AGENDA OF THE LANDMARKS COMMISSION

WEDNESDAY, NOVEMBER 17, 2021, 4:30 PM
Virtual Meeting. Public may join via Zoom.

(COA 21-14) Consideration and possible action on a design review for already-installed front porch railings located at 736 S. Jefferson Street.

(COA 21-31) Consideration and possible action on a design review for door and window replacements located at 840 S. Jefferson Street.

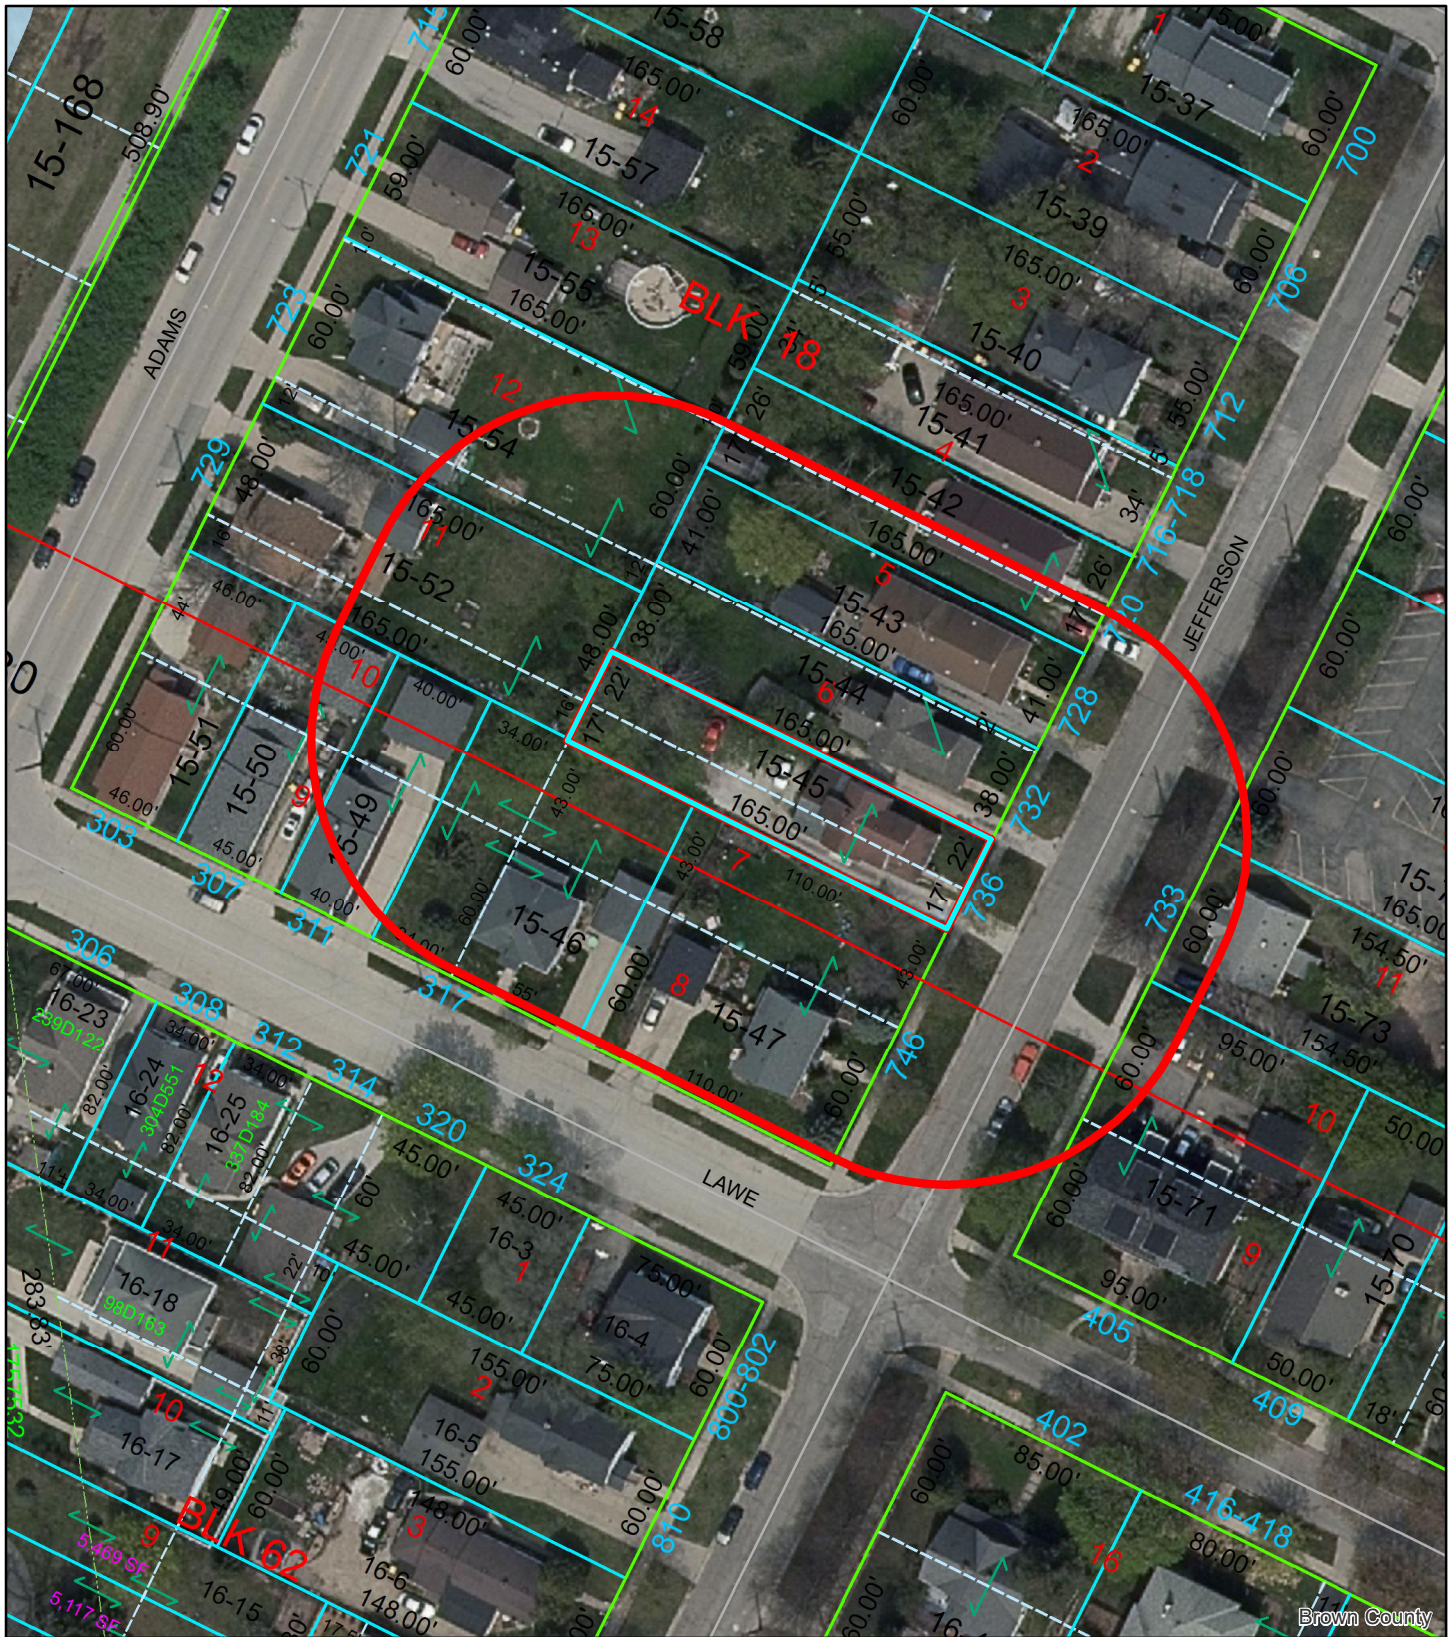
LC staff notes that the previous stair railings were not historic, and no historic images are readily available showing what a historically accurate design might have been.

The metal step railings installed here do not appear to have a negative impact to the historic character or integrity of either this property or the surrounding district. Although the new railing may not be historically accurate, it is nonetheless much more appropriate to the style and character of this house than the railings that have been removed. LC staff recommends that the LC find the new railings qualify for a COA, and that a COA be issued for the work already finished (thereby satisfying the requirements of ordinance 44-1552(2)).

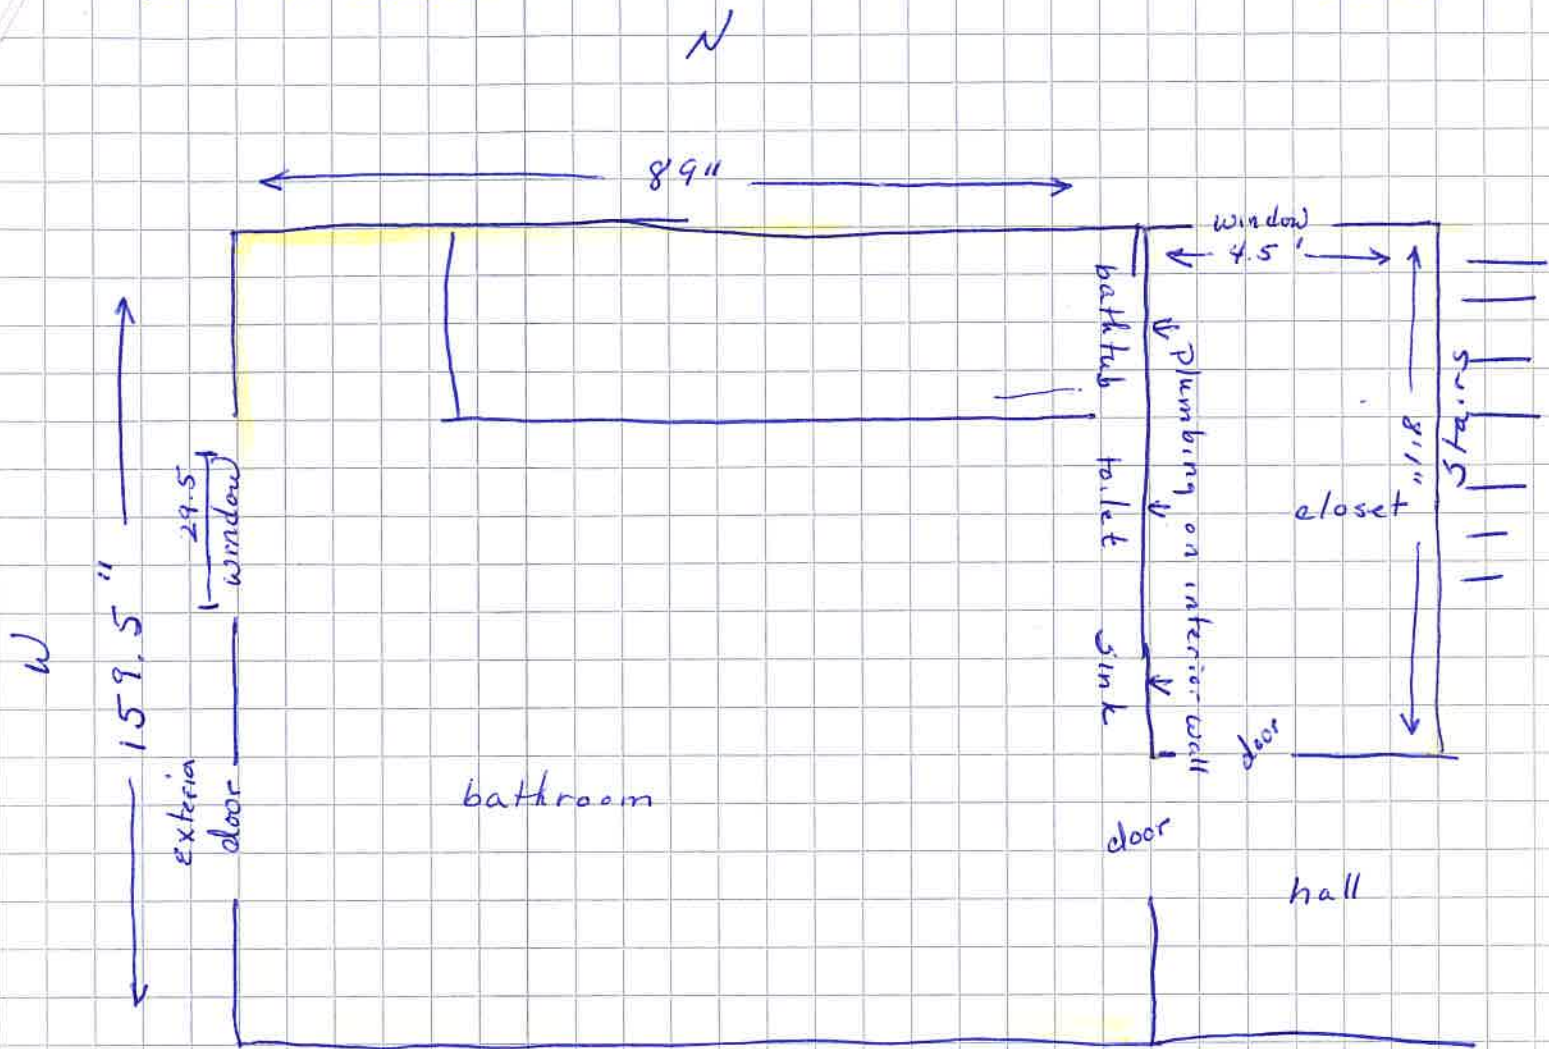
LC staff notes that “SDL” (simulated divided light) windows do not have a spacer piece between the interior & exterior applied grilles (between the panes of glass). Past experience suggests that the LC requires the spacer between interior & exterior grilles (Pella calls this an “ILT” integral light technology grille).

LC staff further notes that the Wisconsin Historical Society / SHPO requires a visual light transmittance of 72 or higher (a VT rating of 0.72). Reference: <https://www.wisconsinhistory.org/Records/Article/CS4308>

LC staff recommends approval of the proposed exterior changes provided that the new window specifications are changed to reflect "ILT" grilles (versus "SDL" grilles). A project description provided by the applicant describes the new windows as "true divided-light", but the manufacturer specifications do not agree (SDL is not true divided light – IDL is appropriate and matches what the owner describes).

Based on Wisconsin SHPO requirements, the proposed replacement windows are inappropriate due to their visual light transmittance of 50 & 47 versus the SHPO requirement of 72 or higher. This is a state-specific requirement and may not be typical elsewhere in the country. Due to state requirement, LC staff is compelled to recommend that replacement windows with a VT rating of 0.72 or higher be specified, but recognizes that this may be a more important consideration when evaluating commercial buildings that are individually listed (as opposed to contributing houses in a district).
